# Understanding Pre-post Coefficient Difference Limit Equation

# In reference to comment # I-220

# Pre-post equalizer coefficient difference limit

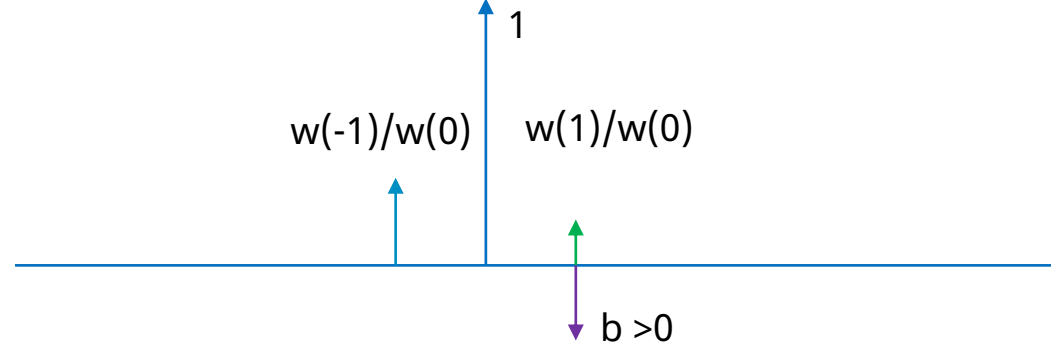
The pre-post equalizer coefficient difference limit equation that was amended to reflect the addition of the DFE tap  $b$  in draft 2.2 to  $|w(1)/w(0) - b(1) - w(-1)/w(0)|$  where  $w(i)$  are the FFE coefficients and  $b(1)$  is the DFE tap now normalized wrt.  $OMA_{TDECQ}/2$  was kept as is, as the proposed normalization in [1] corrects two approximations that existed in the original equation.

Qi? What is the meaning of the quantity “ $w(1)/w(0) - b(1) - w(-1)/w(0)$ ” ?

Ans: it is a fraction of a baud or UI, and as such it carries a timing information associated with the sampled waveform

# Concern raised against D3.0 wrt. Coefficient limit equation

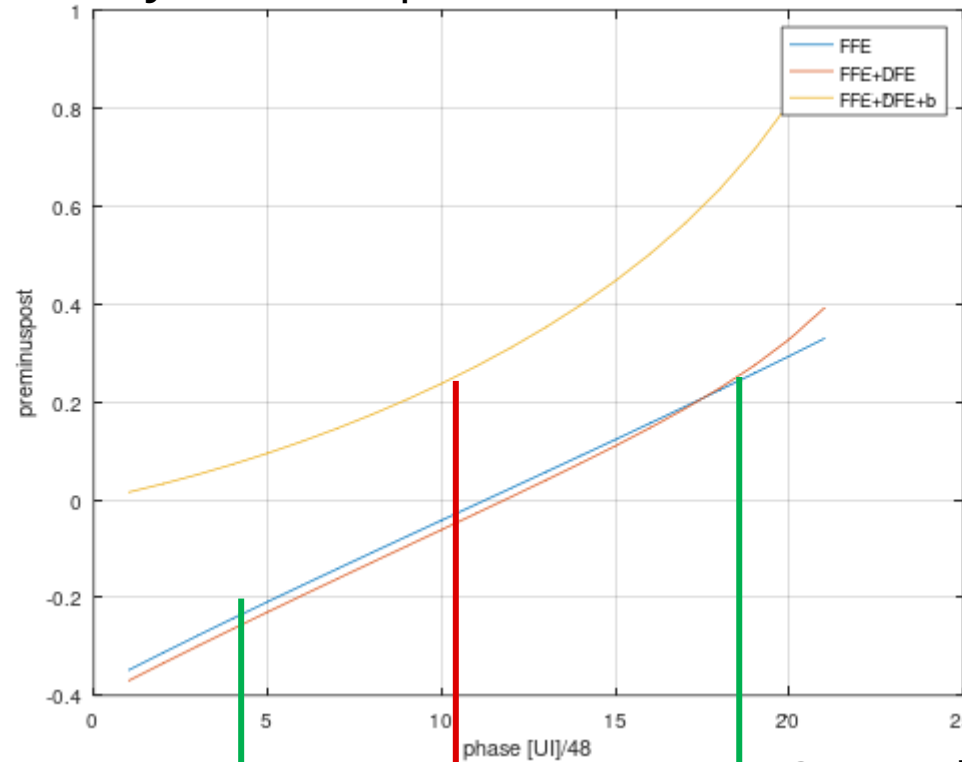
<b>CI 180</b>	<b>SC 180.9.6.3</b>	<b>P480</b>	<b>L17</b>	# <span style="border: 1px solid black; padding: 2px;">I-70</span>
El-Chayeb, Ahmad		Keysight Technologies Inc		
<i>Comment Type</i>	<b>TR</b>	<i>Comment Status</i> <b>X</b>		
Including the DFE tap b1 in the limit: $ w(1)/w(0) - b(1) - w(-1)/w(0)  \leq .25$ makes the implementation makes the limit non-linear limit, introduces complexity and increases the measurement time.				
<i>SuggestedRemedy</i>				
Suggested remedy: Remove b(1) from the equation				
<i>Proposed Response</i>		<i>Response Status</i> <b>O</b>

A comment was made against D3.0 to modify the pre-post equalizer coefficient limit equation from  $|w(1)/w(0) - b(1) - w(-1)/w(0)| \leq 0.25$  to  $|w(1)/w(0) - w(-1)/w(0)| \leq 0.25$

We propose to retain the pre-post coefficient difference equation in its present form:

$$|w(1)/w(0) - b(1) - w(-1)/w(0)| \leq 0.25$$
